**King's Mark
Environmental
Review
Team
Report**

**HUBBARD FARMS
ESTATES WEST
SUBDIVISION
WEST HAVEN,
CONNECTICUT**

Environmental Review Team Report

FEBRUARY 1988

Figure 2

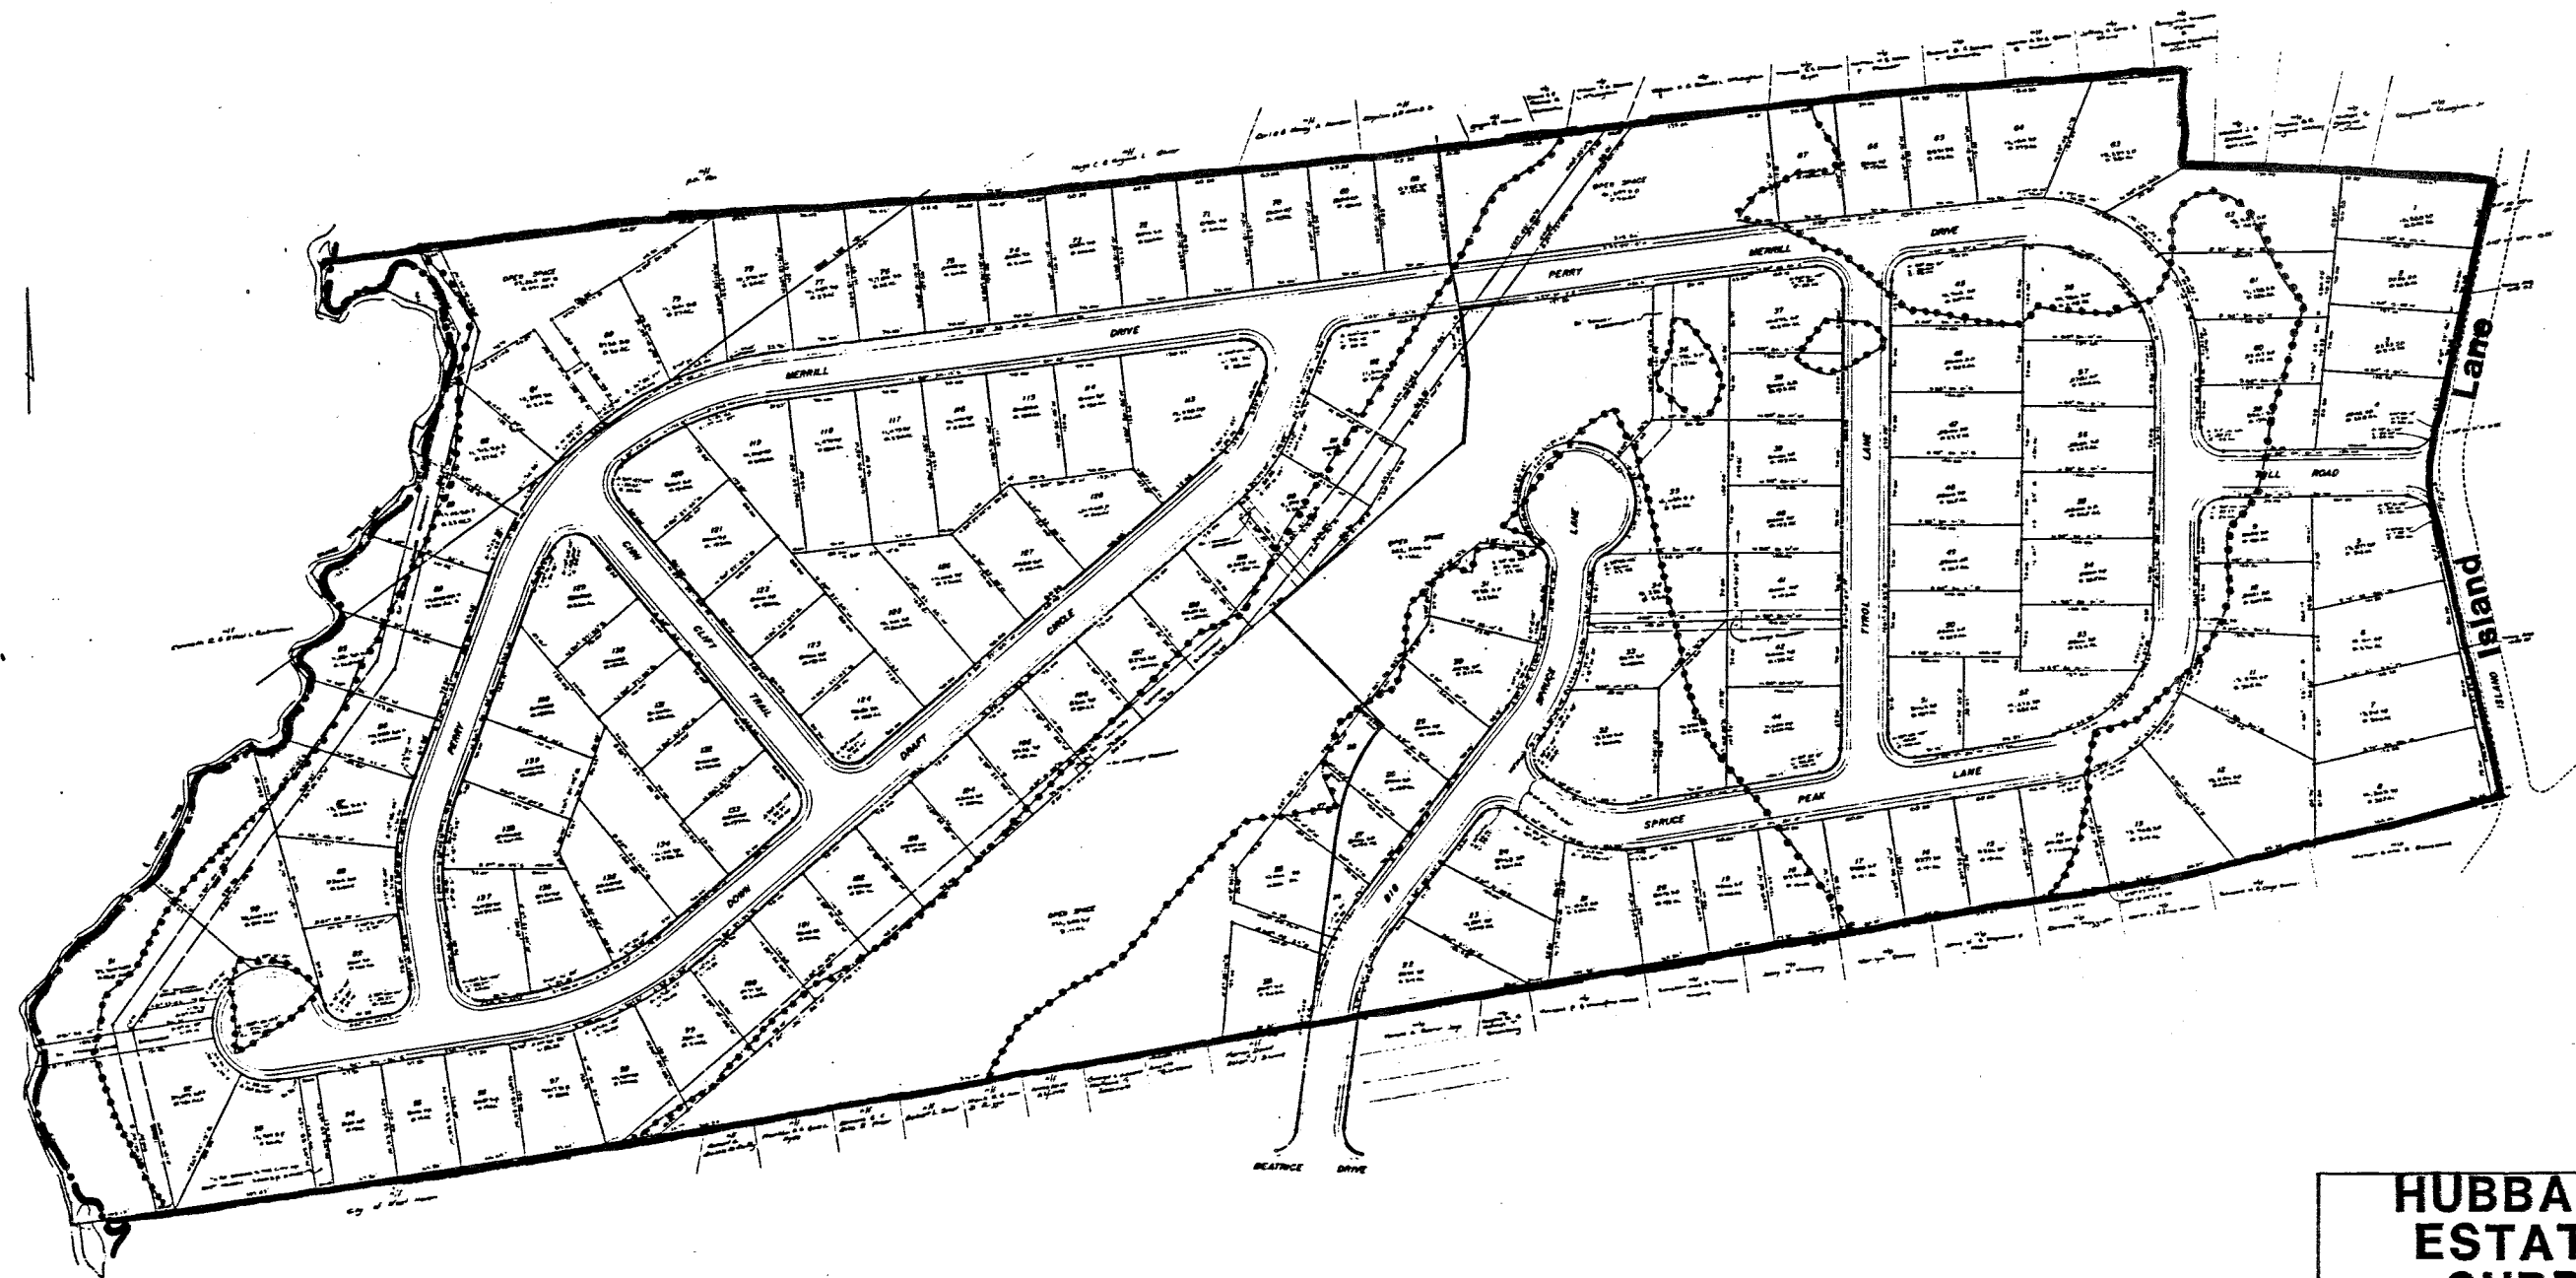
7. The cul-de-sac and detention basins on the eastern side should be located so that fill slopes will not affect the floodplain wetlands.
8. The road crossing over the east branch of Oyster River needs further investigation and modification. It is recommended that boring data be obtained in this area to find out if the highly variable floodplain soil can support this fill. The amount of fill needed, (and thus impact) could be lessened by the use of a bridge, box culverts or arched culverts.

- c. Maintain buffer strips of existing vegetation between disturbed areas and wetlands. On plans submitted, steep slopes along the Oyster River and its tributary are shown as graded areas. Consequently, vegetation would be removed and soils disturbed immediately adjacent to areas which are classified as important wetlands in the Biological Evaluation submitted with the plans.

- d. Plan for surface drainage. There are currently several watercourses draining the hillsides along the Oyster River and its tributary stream. The plans show that almost all of these would be eliminated. This action would destroy the natural wetland drainage network. In addition, it would increase the risk of erosion from surface flows which could concentrate and reestablish a new drainage pattern in less stable cut and fill materials.

2. The detention basin encroaching on the tributary stream wetland should be moved uphill out of the floodplain as the wetland has water detention capabilities. Stable outlets should be extended accordingly.

The City of West Haven requires a 25 foot buffer zone around wetlands from any type of disturbance. The proposed development indicates no provision for such buffer zones. In fact, some filling and alteration of the wetland along the East Branch of the Oyster River will be necessary to install the detention basin, as the proposal indicates. Buffer zones are an integral part of wetland preservation. Such areas provide feeding and breeding habitat for many forms

Figure 7

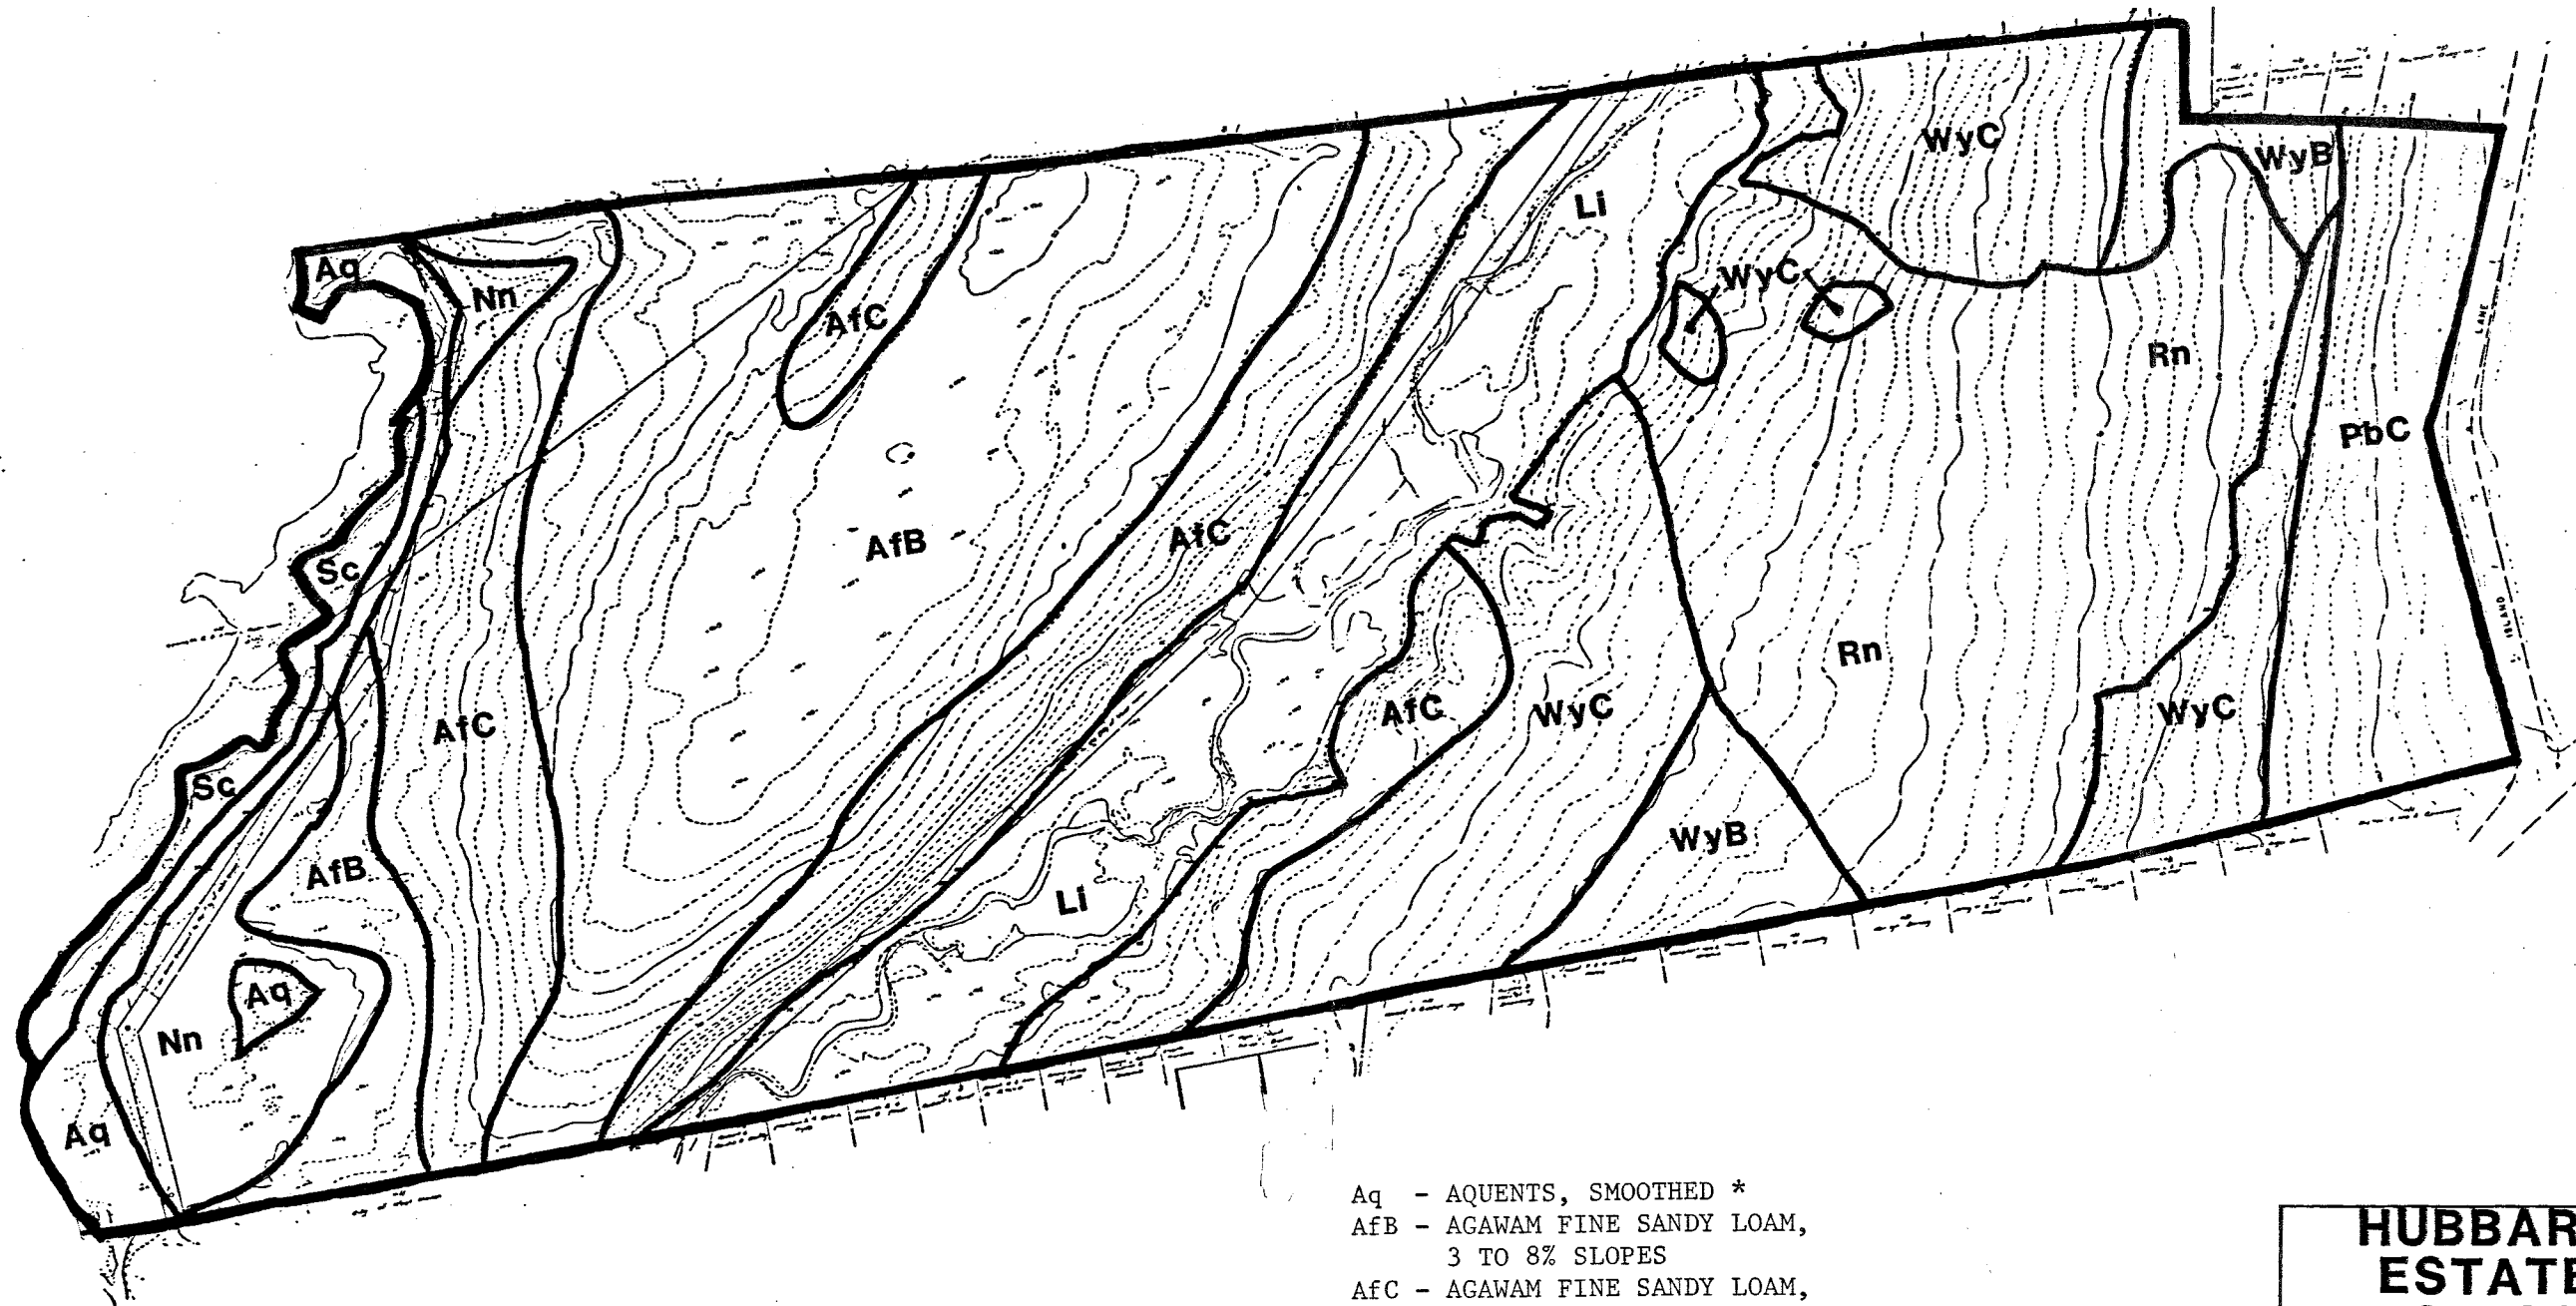
1. Small watercourses have not been located and shown on the plans. They are regulated areas and are an important engineering limitation to locating roads, driveways and homes.

2. Included in the areas mapped AfC is a narrow area of steeper slopes (15%) along the east branch of Oyster River. Also included are small areas of disturbed soils along the sewer line.

3. Included in areas mapped RN are areas of Ridgebury soils on 8 to 15% slopes. Dominant slopes are 3-8%.
4. Included in areas mapped WyC are small areas of well drained soils with loose, sandy substrata. These areas are located at the base of the till sideslope.

5. Included in areas mapped Li are small areas of poorly drained glacial till and outwash soils.
6. Because of the large amount of surface and subsurface water moving downslope on the eastern sideslope, the proposed road/home drainage system may not completely eliminate the seasonal wetness problem. This is particularly true on proposed lots that border the northern and southern property boundaries (62-67, 12-22). Surface and subsurface water does enter the parcel from the surrounding developed areas. Homes with partial basements or no basements may be more practical on many proposed lots.
